CITY PLAN COMMISSION STAFF REPORT

Development Plan, serving as a preliminary plat

Case	Request
Docket Item 1.1	Development
CD-CPC-2020-00102	Plan

Location	9130 McGee Street
Area	0.24 acre or 10,491 sq. ft.
Zoning	R-7.5
Council	6 th
County	Jackson
School District	Center

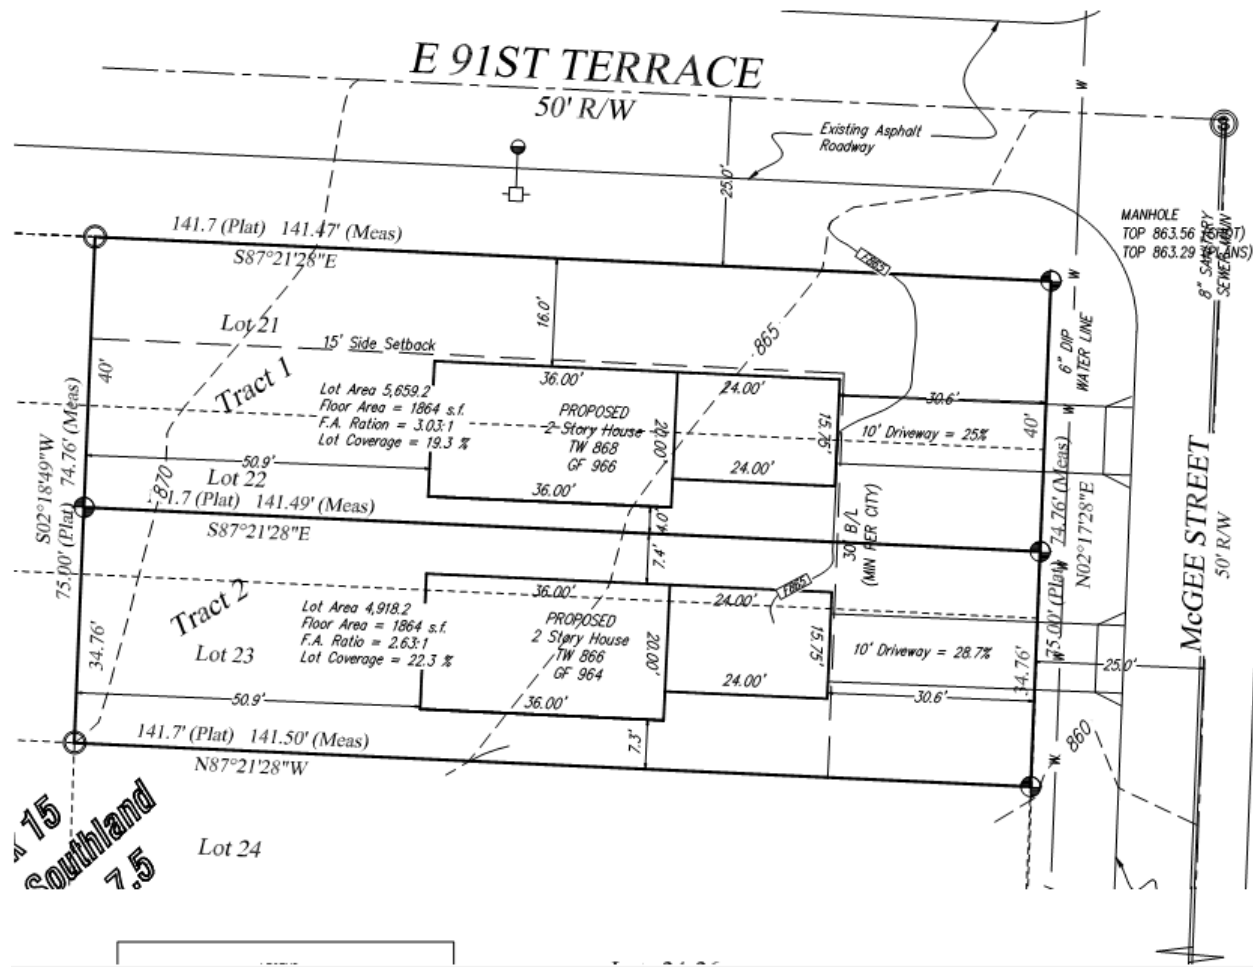
The development plan proposes establishment of two lots, on top of the three lots originally platted as Lots 21, 22, and 23, Block 15, Moore's Southland Addition.

- Zoning of the property is R-7.5. This designation allows single family residential use and requires a minimum lot size of 7,500 sq. ft.
 - The northernmost Tract 1 is 5,640 sq. ft. Applicant will request a deviation of required lot area in the amount of 1,860 for this lot (7,500 sq. ft. required vs. 5,640 sq. ft. provided) from the City Council
 - The southernmost Tract 2 is 4,917 sq. ft. Applicant will request a deviation of required lot area in the amount of 2,583 for this lot (7,500 sq. ft. required vs. 4,917 sq. ft. provided) from the City Council

- Required minimum lot width is 50 ft.
 - Tract 1 is 40 ft. in width. Applicant will request a deviation of required minimum lot width in the amount of 10 ft. for Tract 1.
 - Tract 2 is 34.76 ft. in width. Applicant will request a deviation of required minimum lot width in the amount of 16 ft. for Tract 2.
- All setbacks are in compliance, so no deviations are necessary.
- The plan shows maximum paved front yard area of 40% is not exceeded, so deviation is not requested.

1. That the applicant receive deviations to the minimum required lot area as follows:
 - a. For Tract 1 in the amount of 1,860 sq. ft. (7,500 sq. ft. required; 5,640 sq. ft. provided);
 - b. For Tract 2 in the amount of 2,583 sq. ft. (7,500 sq. ft. required; 4,917 sq. ft. provided).
2. That the applicant receive deviations to the minimum required lot width as follows:
 - a. For Tract 1 in the amount of 10 ft. (50 ft. required; 40 ft. provided);
 - b. For Tract 2 in the amount of 15.24 ft. (50 ft. required; 34.76 ft. provided).
